DEVIATION REQUEST (Attach diagrams, figures, and other documentation to clarify request)

A deviation from the standards of or Chapter 4, Section 4.3.5.E.2, **Utility Design: Utility Location of Underground Utilities (Longitudinal Placement)** & **Appendix F, Standard Drawings, SD-4-3** - of the Engineering Criteria Manual (ECM) is requested.

STORM 2
STA 1+15.22 TO STA 2+93.36
(PUBLIC/PRIVATE)

Urban NonResidential Collector Roadway Utility Placement Cross Section	
REVISION DATE: 3/15/12	FILE NAME: SD_4-3

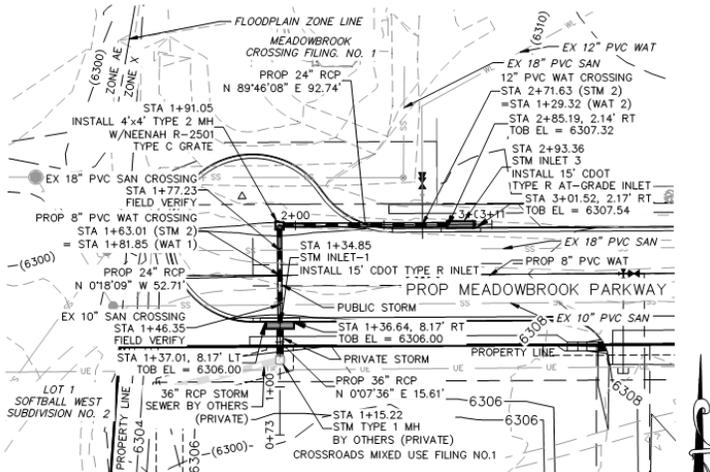
A deviation is requested from the above standard, which requires storm sewer to be longitudinally placed 6' from the striped median edge (not under the curb and gutter), according to the standard drawing (SD 4-3) below under a non-residential collector roadway (Proposed Meadowbrook Parkway).

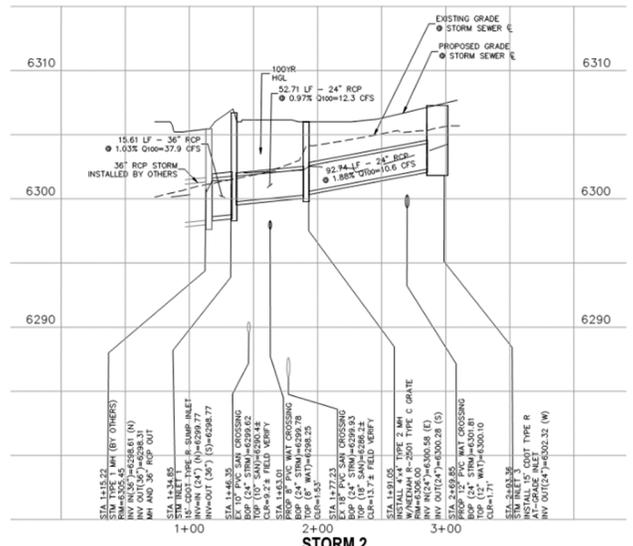
The deviation is being requested due to geographical limitations caused by adjacent existing utilities that inhibit the ability to construct the storm sewer in the standard location with adequate utility spacing.

The proposed solution is to install the storm sewer in the location shown in the exhibit below. This location is under the proposed curb and gutter, as compared to the standard drawing above. The Neenah R-2501 grated inlet is used in the proposed condition to capture bypassed flows from the upstream inlet, and is in-line with the future extension of Meadowbrook Parkway to be replaced as a curb inlet.

Utility spacing constraints, water lowering design considerations, existing infrastructure locations, maintenance of the storm sewer, proposed dry utilities, and future use of the grated inlet as a curb inlet were all considerations in determining the most efficient longitudinal placement of this storm sewer.
